**SUBJECT:** NuScale Power, LLC Supplemental Response to NRC Request for Additional Information No. 466 (eRAI No. 9482) on the NuScale Design Certification Application

## **Response to Request for Additional Information Docket No. 52-048**

**NRC Question No.:** 06.02.01.01.A-18

### **Conservatism in the NPM Initial Conditions for the CNV Safety Analyses**

Figure 6.2-2a: Containment Vessel Assembly

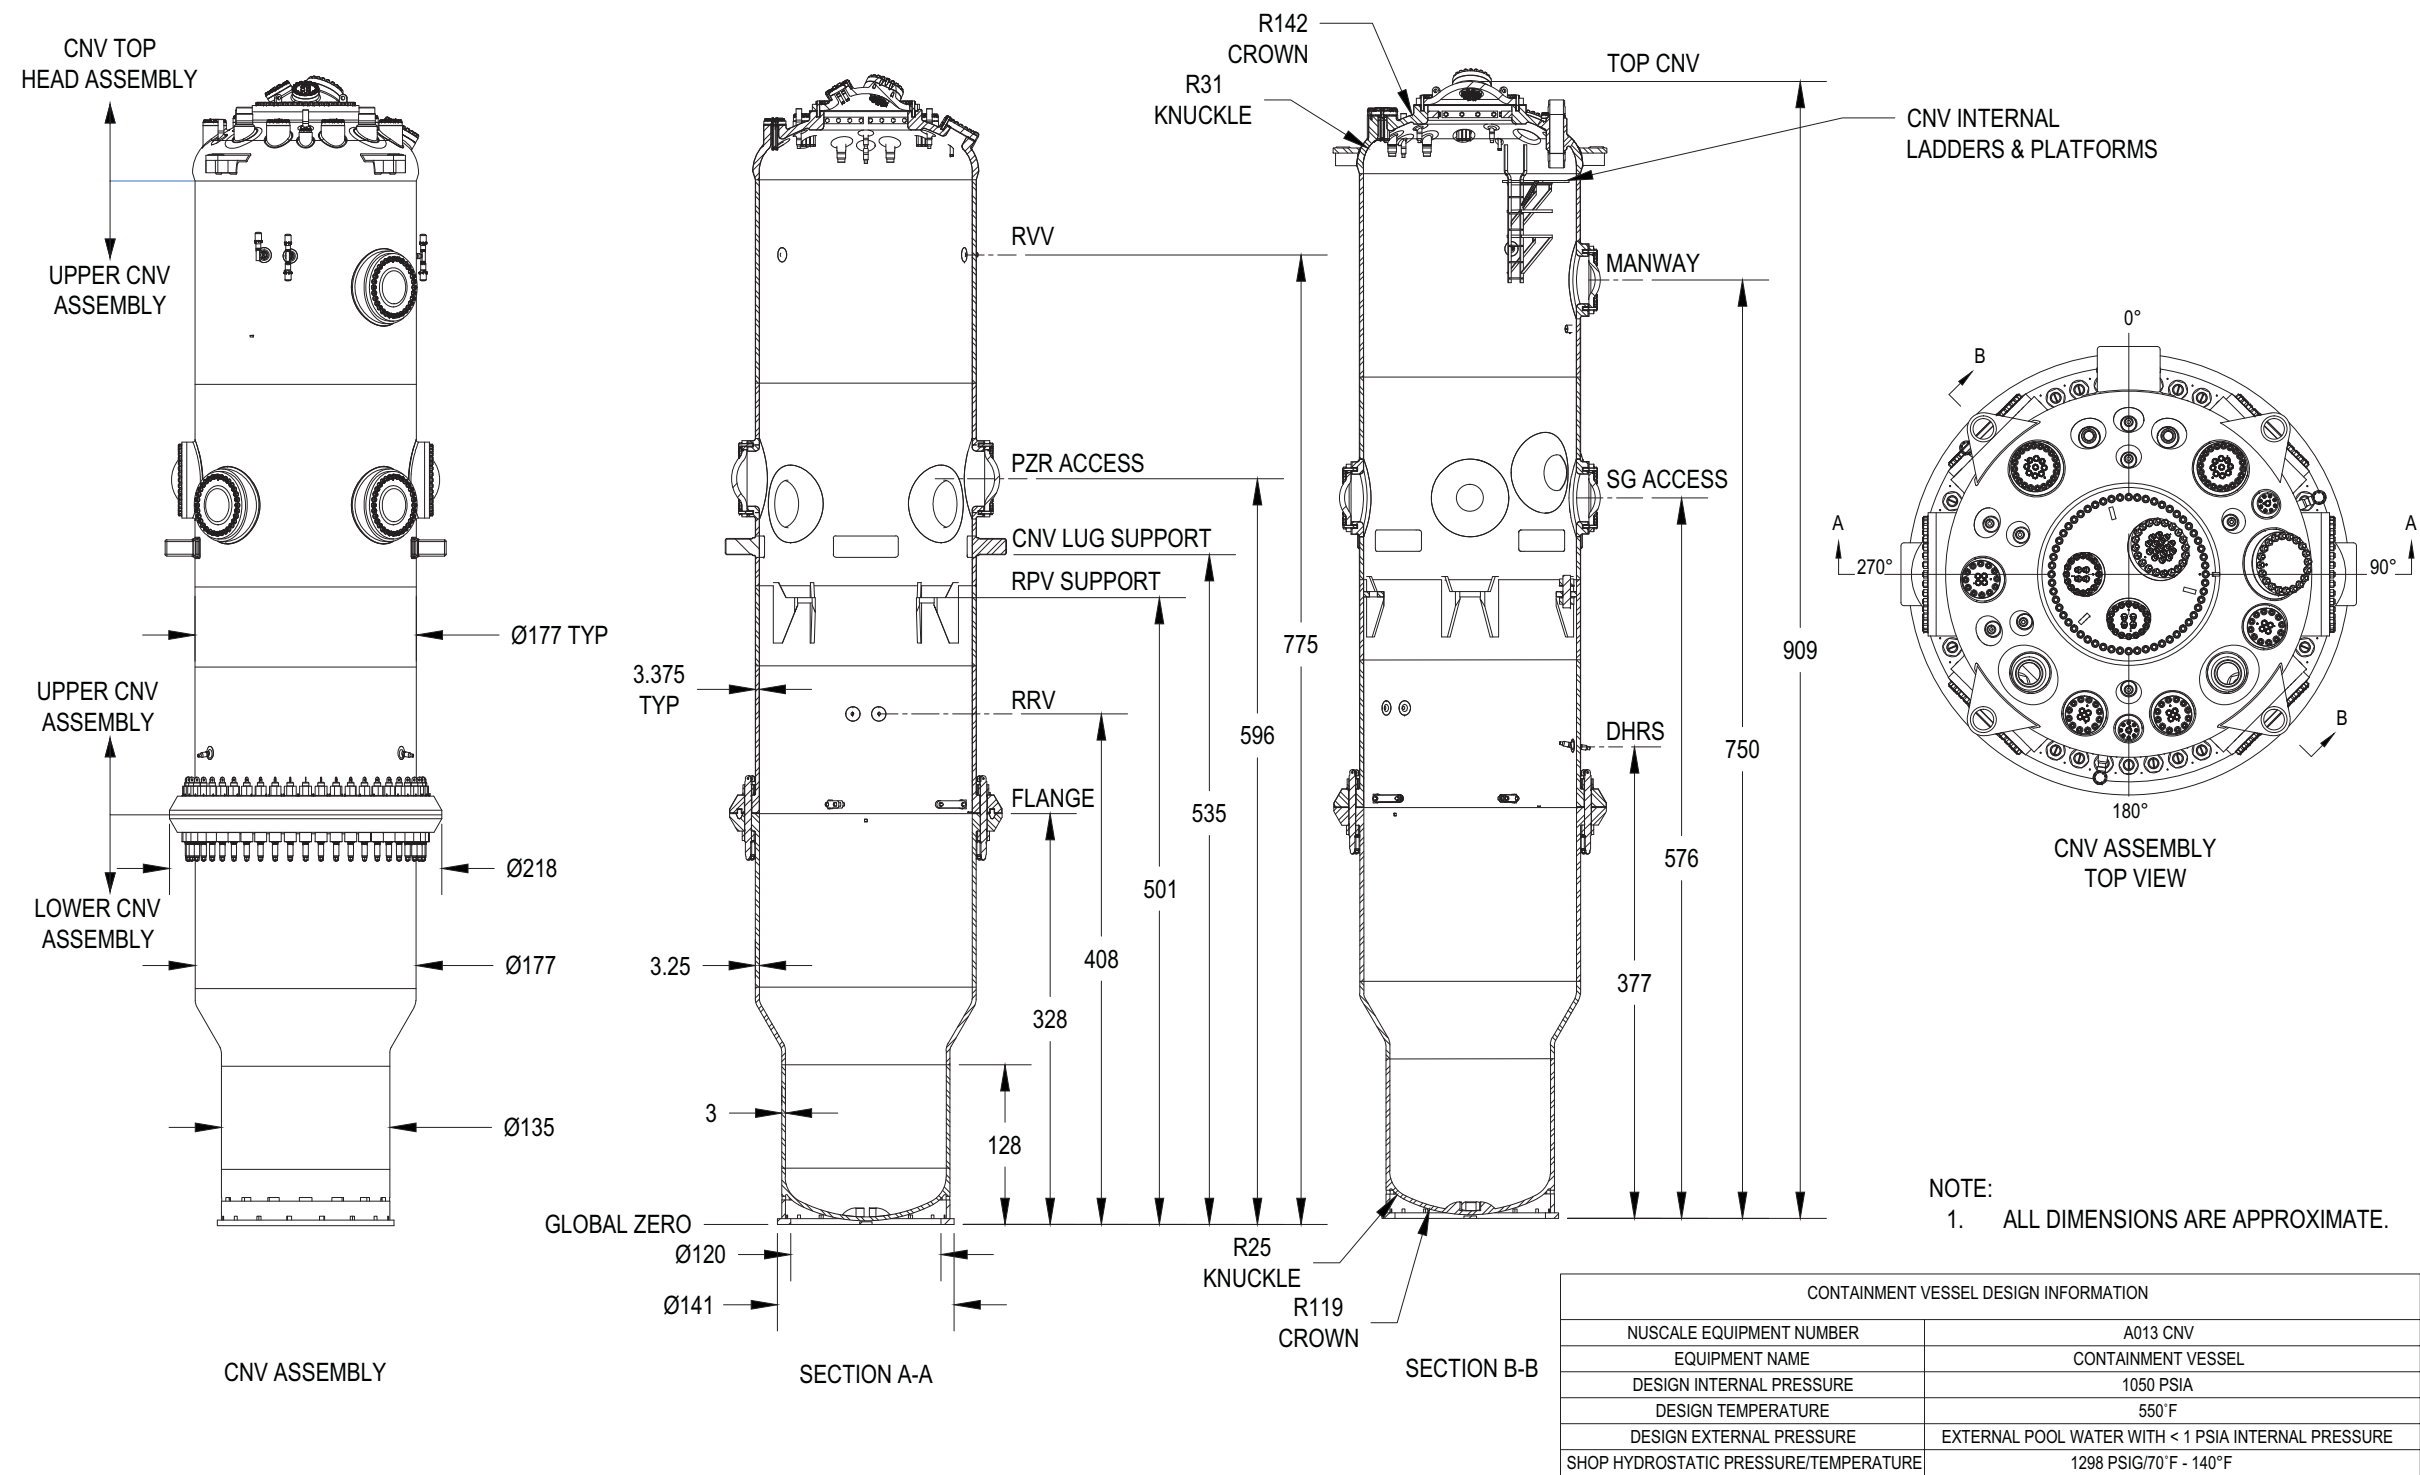
Section 6.2.1.6, Table 6.2-1 and Figure 6.2-2a are updated to reflect the new hydrostatic pressure values of 1298 psig at the highest point of the CNV test boundary and 1375 psig at the lowest point of the test boundary, along with the new CNV design pressure value. Section 6.3.2.4 and Table 6.3-2 are updated to indicate that the external design pressure for the ECCS valves and hydraulic lines have an exterior design pressure of 1050 psia, which is the new CNV design pressure value.

Containment Parameter	Value
<b>Design Conditions</b>	
• Internal Design Pressure	10 <del>50</del> <del>00</del> psia*
• External Design Pressure	60 psia
• Design Temperature	550 °F
• Design Maximum Containment Leakage	17.5 SCFH
• UHS Pool Water (Avg) Temperature	212 °F (boiling)
• Reactor Building Air Temperature (°F)**	65 °F - 85 °F
<b>Normal Operating Conditions (nominal)</b>	
• Internal CNV Pressure	less than 0.1 psia
• External CNV Pressure	60 psia
• CNV Temperature (Atmosphere)	100 °F
• UHS Pool Water Level (See Figure 9.1.3-5)	68 - 69 ft (pool level) 93 - 94 ft (building elevation)
• UHS Pool Water Volume - from normal operating level (69 ft) to top of weir (45 ft) as shown in Figure 9.1.3-5	4 million gallons
• UHS Pool Water (Avg) Temperature	100 °F
• Reactor Building Air Temperature (°F)	75 ±10 °F
• Lowest Service Temperature	40°F

Figure 3-2 Containment vessel

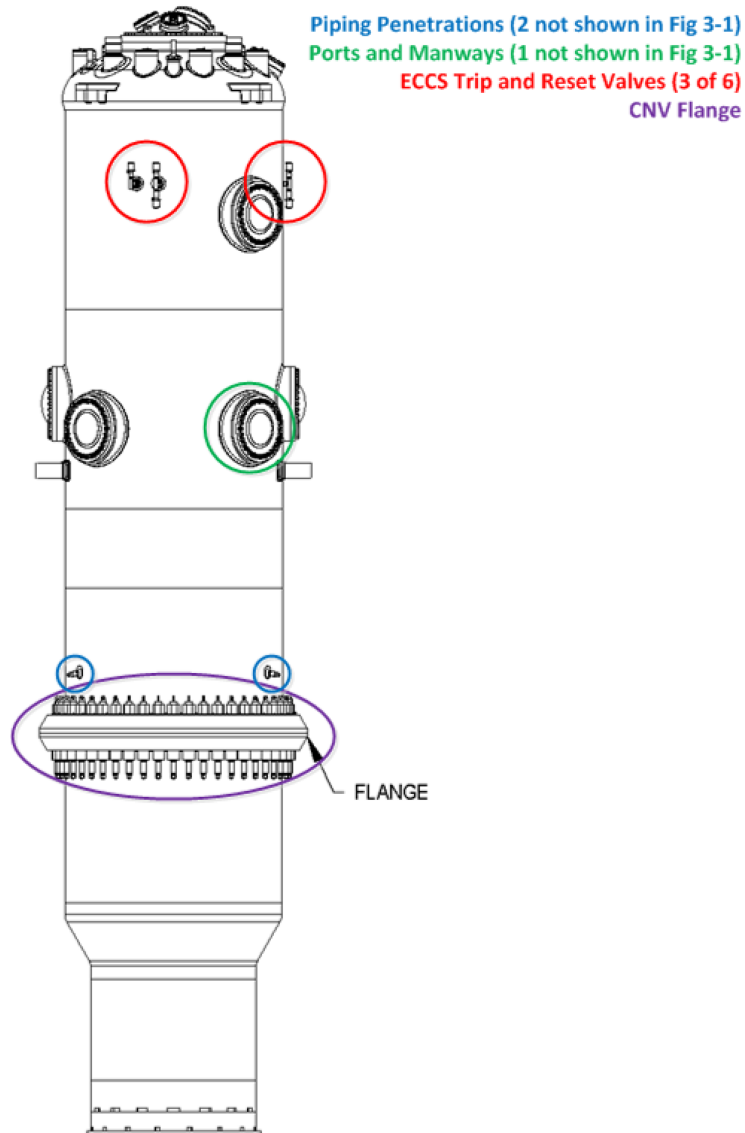
Approximately ~~94-90~~ percent of the CNV is submerged in the ultimate heat sink (UHS) that removes residual core heat during normal and accident conditions. The CNV has a design pressure and temperature referenced in FSAR Tier 2, Section 6.2.1, ~~of 1,000 psia and 550 degrees F~~. The CNV is a steel vessel with relatively low volume (approximately 6,144 ft<sup>3</sup>) compared to other PWR containments and has no internal subcompartments. The design prevents isolated pockets of concentrated gases. The upper portion of the CNV is constructed of low alloy carbon steel with stainless steel cladding on the inside and outside surfaces. The bottom portion of the CNV is constructed of stainless steel. The CNV will be factory fabricated, which facilitates enhanced fabrication quality and testing control.
